**Temporary Warehouse of Construction Materials and Associated Filling of Land
for a Period of Three Years in "Agriculture" ("AGR") Zone
at Lots 1016(Part), 1017, 1028S.A(Part), 1029(Part), 1030(Part), 1031, 1032, and
1033(Part) in DD 113, Kam Tin, Yuen Long, New Territories**

(Application No. A/YL-KTS/1130)

Responses to Departmental Comments

TITLE
PROPOSED AMENDMENT TO LAYOUT
PLAN FOR FIRE SERVICE INSTALLATIONS

LAYOUT PLAN FOR FIRE SERVICE INSTALLATIONS (1:200)

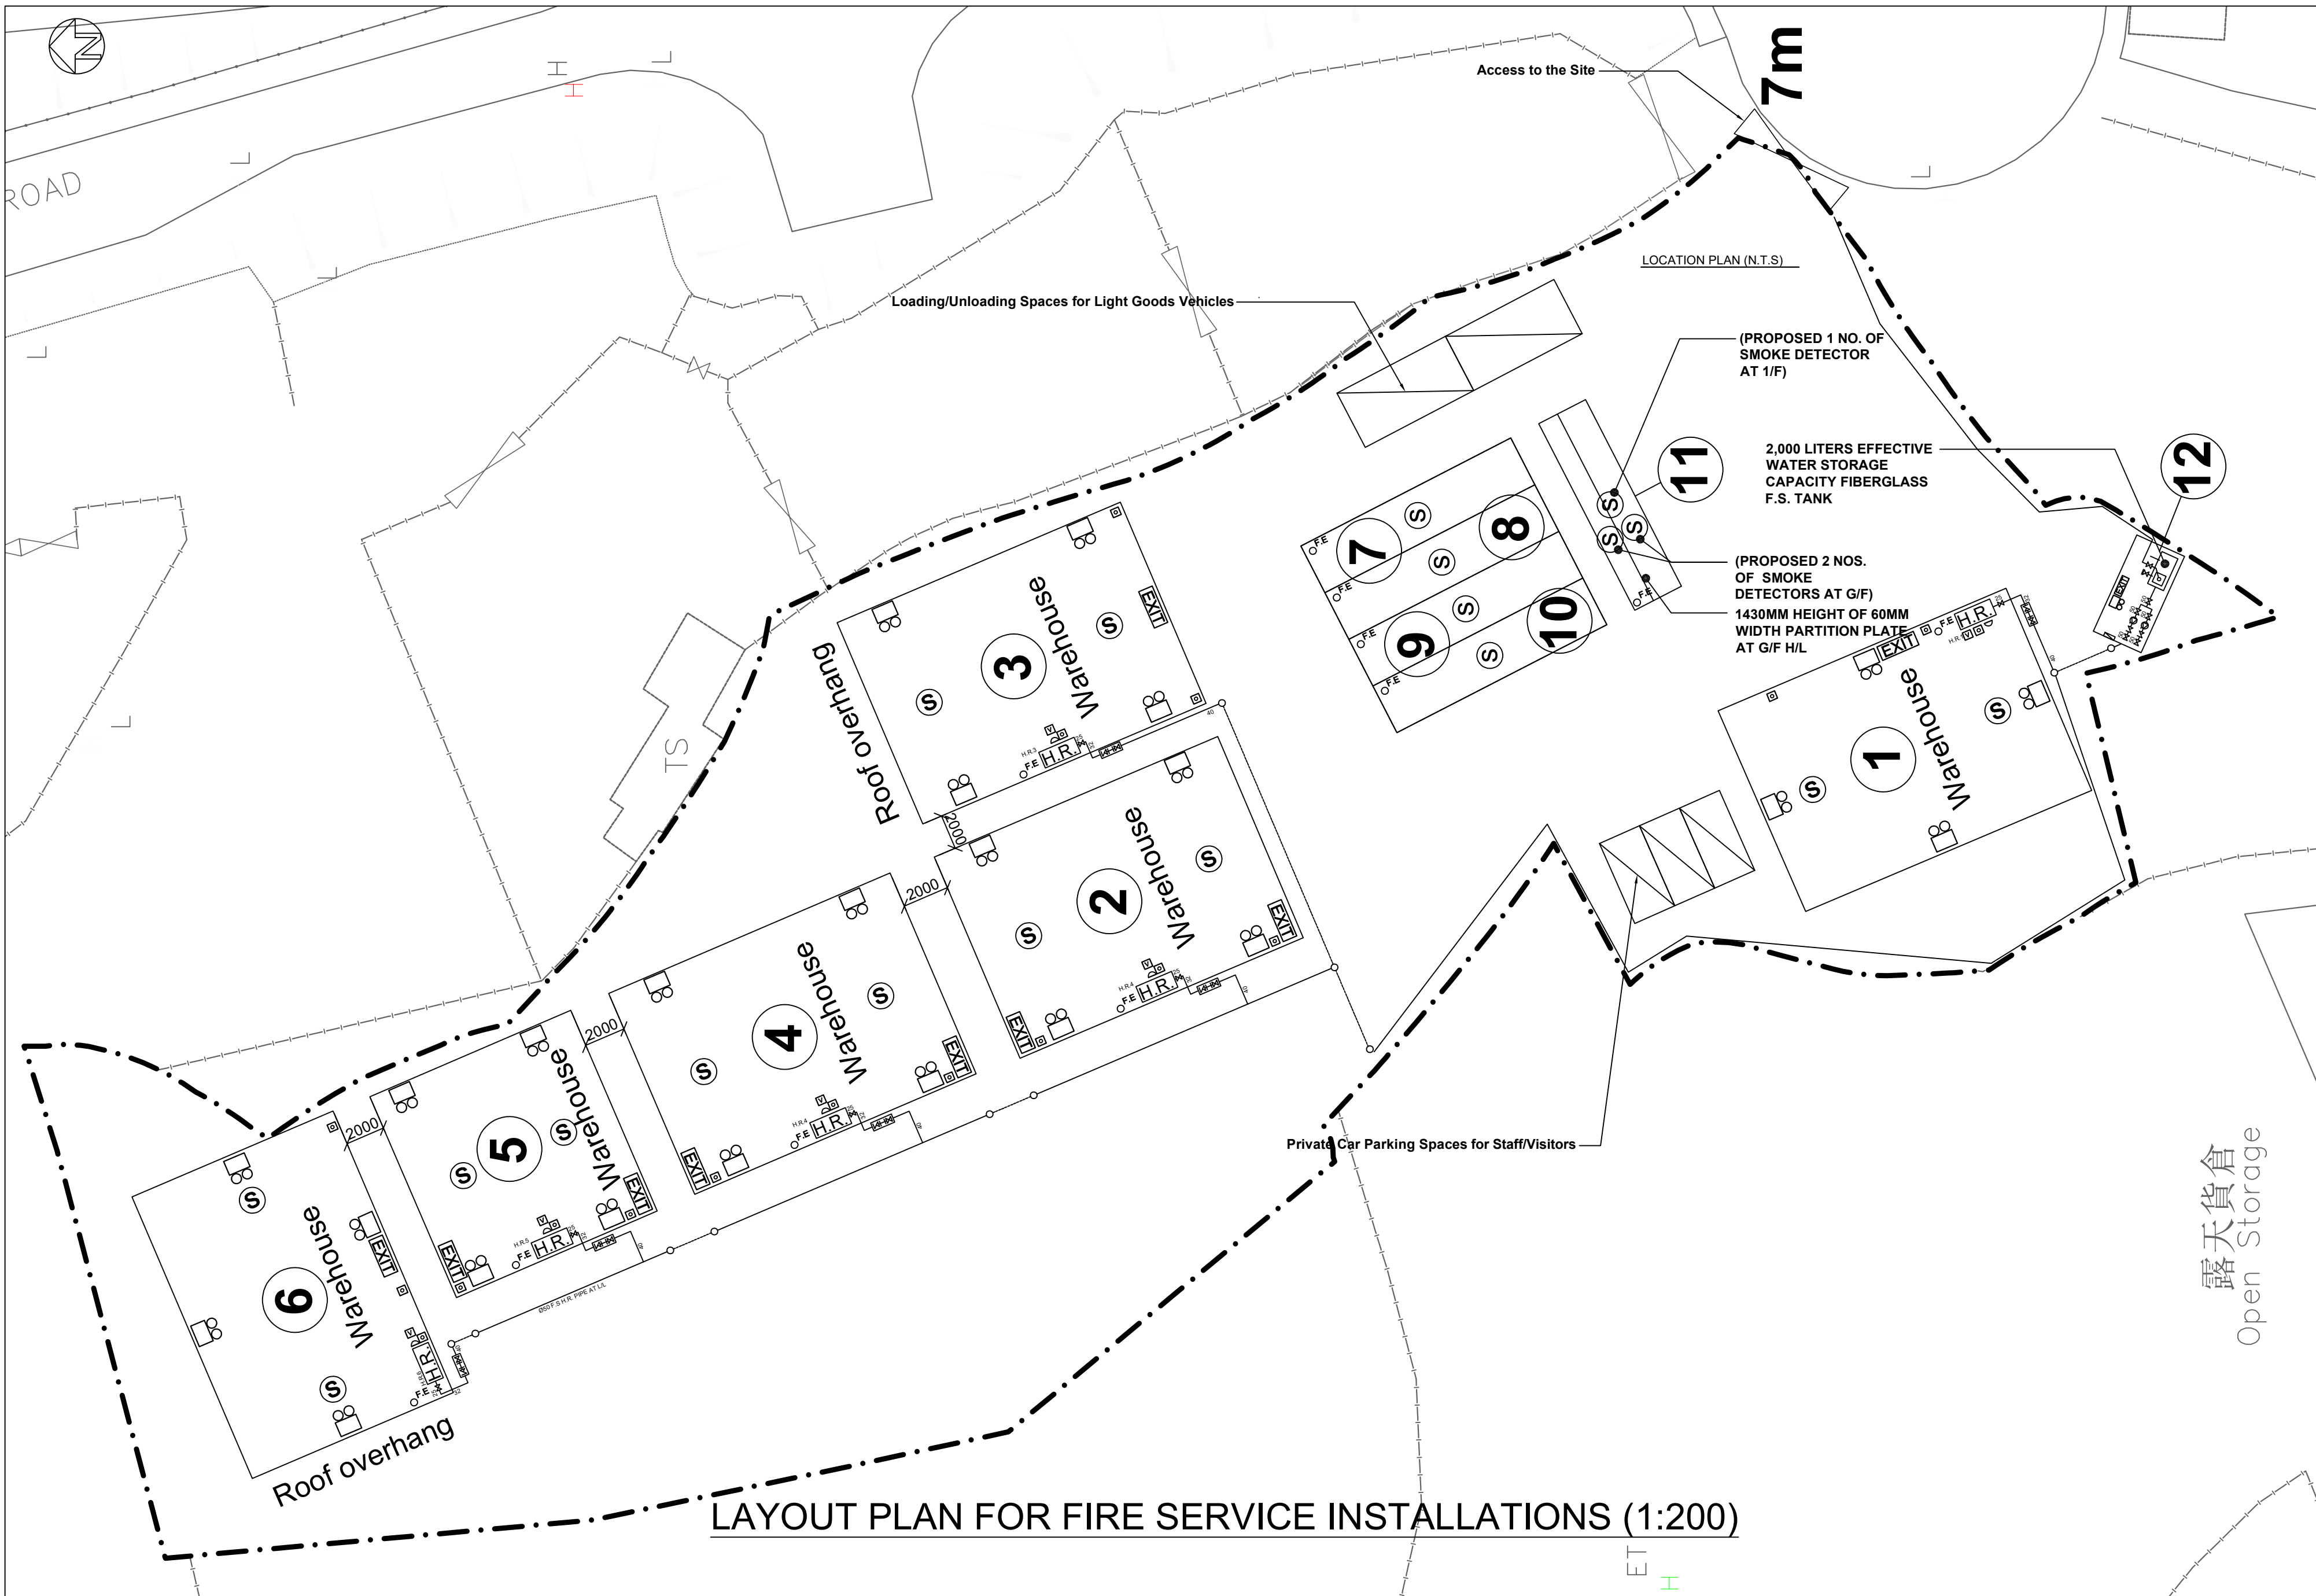
Departmental Comments		Responses
A.	Fire Services Department [Email dated 3.6.2026] (Contact Person: Mr. YUEN Tsz Fung, Tel: 2733 7781)	
	Based on the submitted FSI proposal, his comments are as follows: i. For enclosed structure with gross floor area not exceeding 230 m2, portable fire extinguisher and stand-alone fire detector shall be provided; ii. In relation to item (i) above, if two or more stand-alone fire detectors are installed in an enclosed structure, all detectors shall be interconnected (either wired or wirelessly) such that when one of the detectors is triggered, all connected detectors shall sound an alarm simultaneously; iii. Stand-alone fire detectors shall be provided in accordance with the “Stand-alone Fire Detector General Guidelines on Purchase, Installation & Maintenance [Sep 2021]”; iv. Separation distance between each structure shall be clearly indicated on the plan; v. In relation to item (iv) above, structures on the same site are regarded as adjoining structures if they are less than 1.8 m apart. In this regard, sprinkler system, wheeled type dry chemical fire extinguisher, stand-alone fire detector, emergency lighting and directional & exit signs shall be provided if the total floor area exceeds 230 m2; vi. Provision of FSIs shall be demonstrated in form of FS Notes with all relevant standards and specifications; vii. Modified hose reel system, fire alarm system, emergency lighting, directional and exit signs are considered as self-upgrades and are not mandatory requirements of this Department; viii. If the applicant self-initiates the provision of a modified hose reel system, the standard and specification shall be provided in accordance with the “Codes of Practice for Minimum Fire Service Installations and Equipment and Inspection, Testing and Maintenance of Installations and Equipment [September 2022 revision]”;	Please refer to the revised FSIs proposal. The Applicant will provide FSIs facilities to satisfy the requirements of the Fire Services Department accordingly.

ix. If the applicant self-initiates the provision of a fire alarm system, the standards and specification shall be in accordance with “BS 5839-1:2017 and the FSD Circular Letter No. 6/2021”; x. If the applicant self-initiates the provision of emergency lightings, the standards and specification shall be in accordance with “BS 5266-1:2016, BS EN 1838:2013 and the FSD Circular Letter No. 4/2021”; xi. If the applicant self-initiates the provision of directional and exit signs, the standards and specification shall be in accordance with “BS 5266-1:2016 and the FSD Circular Letter No. 5/2008”; and xii. Schematic drawings are not required to be submitted for vetting.
